D3676-1 FULL HEIGHT BUBBLE WINDOW (LH)

D3676-2 FULL HEIGHT BUBBLE WINDOW (RH)

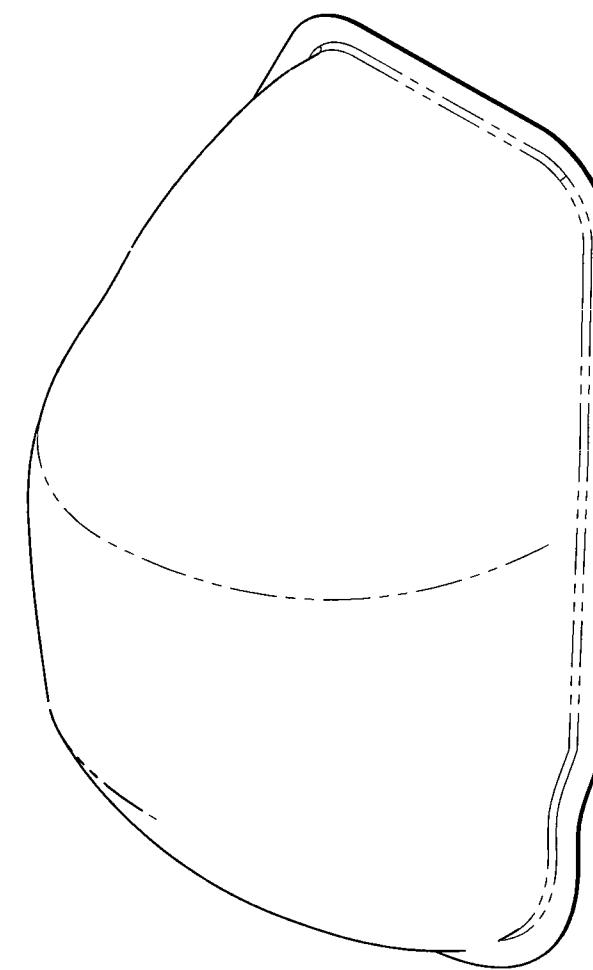
D	UPDATE TOLERANCE ON DEPTH, ADD 20.0 MAX. VERTICAL DIMENSION (SH 2 & 3), NEW VIEW LAYOUTS ON SH 1 & 2	DB	13.12.05
C	ADDED D3676-2 FULL HEIGHT BUBBLE WINDOW (RH), REMOVED NOTES ON SHEET 1, REFORMAT NOTES 6 & 8 ON SHEET 2, D3676-1 WAS "412 BUBBLE WINDOW" NOW "FULL HEIGHT BUBBLE WINDOW (LH)".	AP	12.03.01
B	REVISED TOLERANCE ON MINIMUM THICKNESSES (ZN A8/B8-2). REASON: PRODUCTION FACILITY.	MB	08.10.27
A	NEW ISSUE	MB	08.02.29
REV.	DESCRIPTION		
DESIGN	MB	<b>DART AEROSPACE LTD</b> HAWKESBURY, ONTARIO, CANADA	
DRAWN	DB	DRAWING NO. <b>D3676</b> REV. D SHEET 1 OF 3	
CHECKED	A.P	TITLE SCALE	
MFG. APPR.	SL	FULL HEIGHT BUBBLE WINDOW NTS	
APPROVED	MP	DATE 13.12.05	
DE APPR.	MP	COPRIGHT © 2012 BY DART AEROSPACE LTD THIS DOCUMENT IS PRIVATE AND CONFIDENTIAL AND IS SUPPLIED ON THE EXPRESS CONDITION THAT IT IS NOT TO BE USED FOR ANY PURPOSE OR COPIED OR COMMUNICATED TO ANY OTHER PERSON WITHOUT WRITTEN PERMISSION FROM DART AEROSPACE LTD.
